# 218 North Palm Drive

**STAFF REPORT**  
**CITY OF BEVERLY HILLS**

For the Design Review Commission  
Meeting of January 7, 2010

**SUBJECT:** A request for an R-1 Design Review Permit to allow a new two-story single-family residence, located in the Central Area of the City, south of Santa Monica Boulevard at 218 North Palm Drive. (PL 092 2048)

Revised Design  
Preliminary Approval on  
September 3, 2009

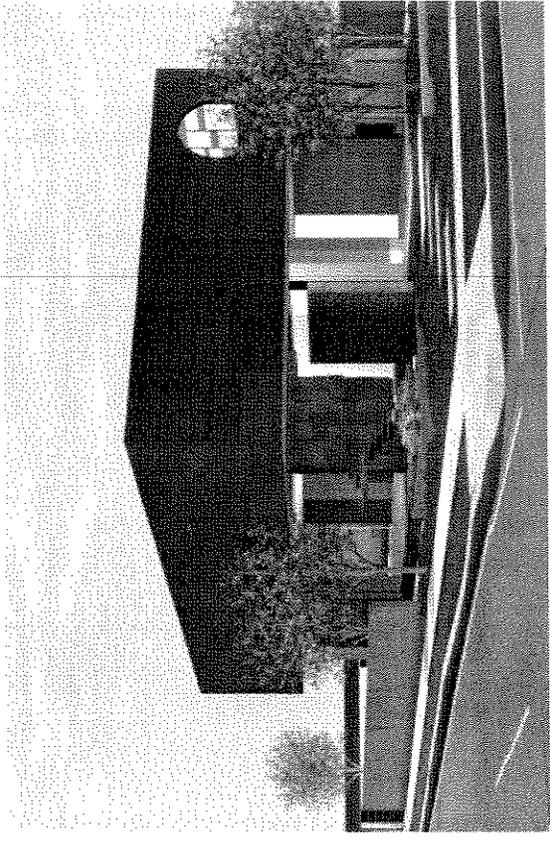
<b>Commission Comment</b>	<b>Proposed Modification</b>
1. Provide more details and modulation on the second floor.	<p><b>Palm Drive Façade:</b> Removal of anodized aluminum panels and round window on the second floor. The second floor façade would include dark glass panels and vertical wood planks. The front façade would be framed with a dark aluminum plate. The wood planks would encroach six inches into the required front setback.</p> <p><b>Dayton Way Façade:</b> The Dayton Way façade would include gray smooth stucco, black brown wood-like veneer, a black etched granite stone wall, a two-story high glass curtain wall and a clear glass window with a metal frame.</p> <p><b>East Elevation facing alley:</b> The east façade would be covered with gray smooth stucco, black &amp; brown wood-like veneer, decorative mosaic wall and glass sliding doors for a balcony with a 36-inch high glass guardrail.</p> <p><b>North Elevation (facing southerly neighbor):</b> The side elevation would include gray smooth stucco, black etched granite stonewall, black &amp; brown wood-like veneer and clear glass with metal frame and an aluminum panel next to it.</p>

## Proposed Revised Design – 1/7/10

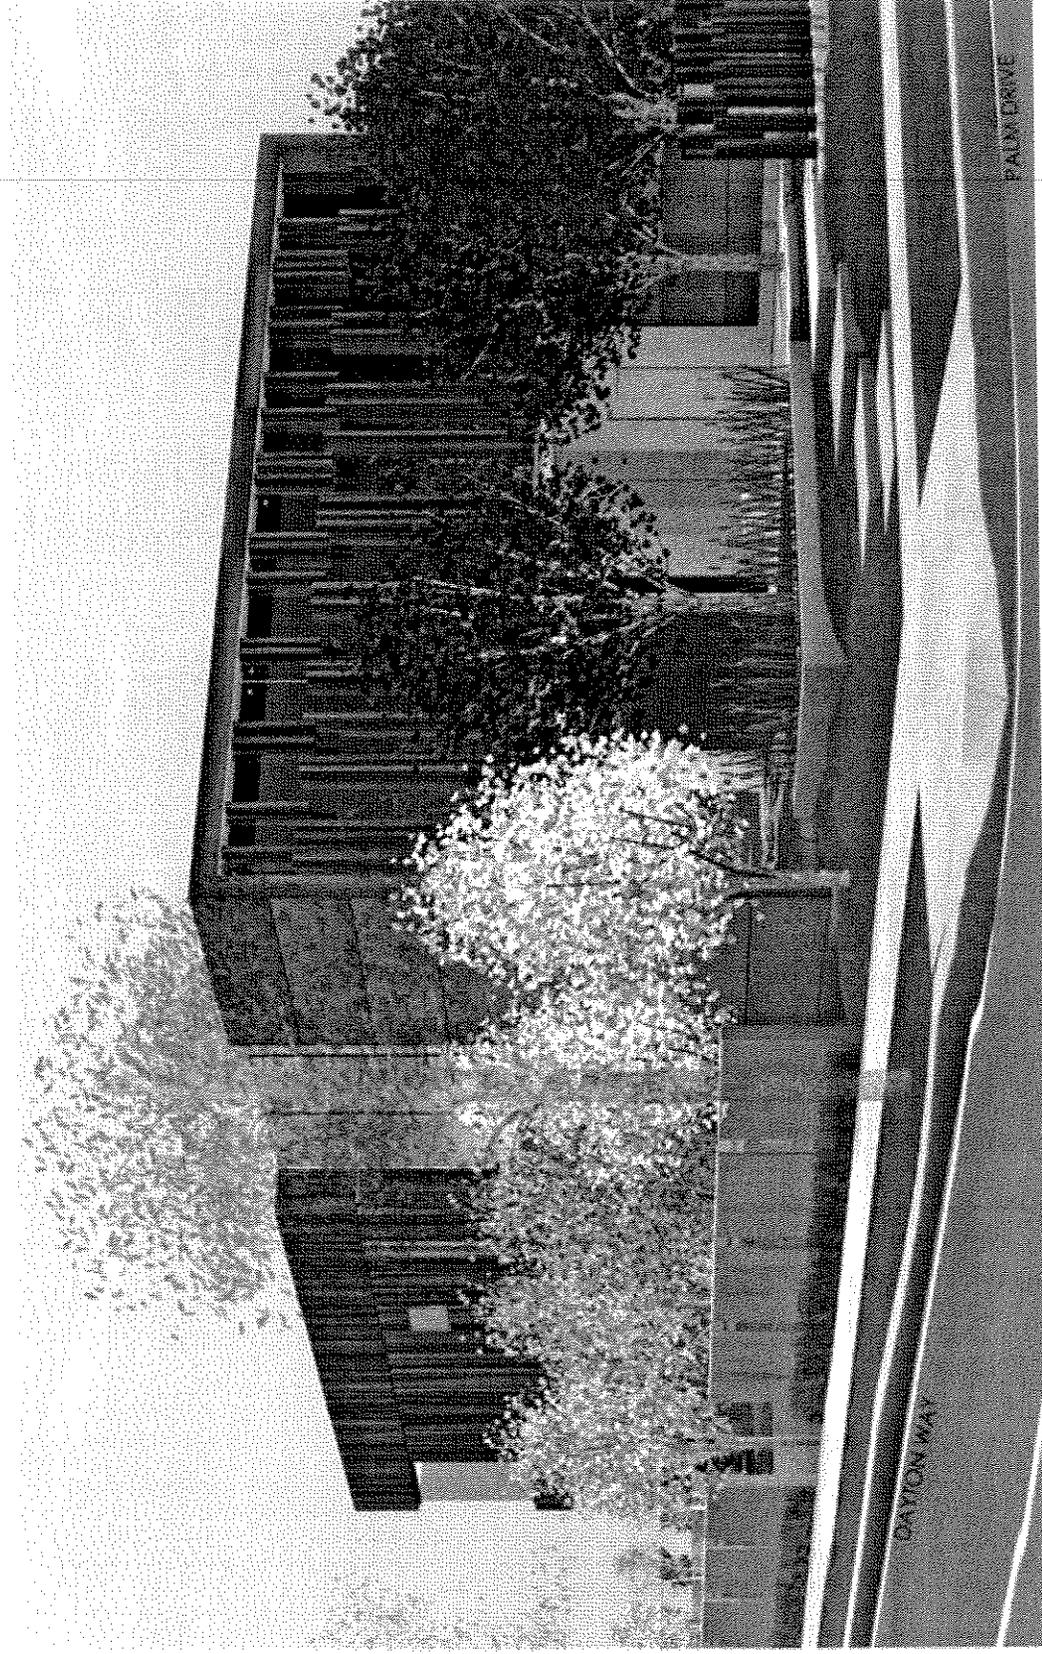
Commission Comment	Proposed Modification
	The proposed revisions do not provide any modulation on the second floor as recommended by the Commission.
2. Conduct a color study and reconsider the materials proposed in order to achieve a more residential feel	As proposed, the revised project does not achieve a residential feel due to choice of material, colors and the building mass on the second floor (please see above).

The applicant has revised the project facade to include new articulation and a new color scheme and materials for the facade. As proposed, the proposed building is set back at the first floor and provides no modulation on the second floor. The proposed revision is a substantial change to the preliminary approved plans. The overall design includes the proposed material and color scheme of brown & black wood-like panels and black glass for the front facade without modulation facing Palm Drive. As proposed, the architectural design of the first floor and second floor does not appear to be internally compatible. The choice of material and color are staff concerns. Therefore, the project, as proposed, does not appear to exhibit a balanced design and internally compatible design scheme.

The revised project includes articulations on facade; however, the proposed revisions do not alleviate the bulk and mass of second floor façade and does not bring a residential feel to the design as recommended by the Commission. While the proposed design complies with the required setbacks, the proposed bulk and mass and choice of material do not appear to enhance the streetscape of this residential street.

Although the revised project includes color change and articulation on the second floor, revision retains its bold horizontal mass on the second floor (specifically on Palm Drive); which is not compatible with the existing architecture in the neighborhood. The design style of the proposed residence appears to have additional scale and mass than the neighboring residences due to the second floor design and the choice of material and colors.

1. The second floor façade shall provide recessed areas to alleviate the bulk and mass created on the second floor.
2. The dark glass panels for Palm façade shall be replaced with a light glass color. The applicant shall consider using materials that include glass and stone for the second floor façade in order to be compatible with the first level architectural treatment.

3. The black brown wood-like panels shall be replaced with a natural wood color pattern.
4. The aluminum panel framing the front façade shall be eliminated from the design to reduce the building mass.

5. The number of vertical wood-like planks on the front facade shall be reduced to simplify the front facade.
6. Any approval by the Commission is for design only; the project is subject to all applicable City zoning regulations.
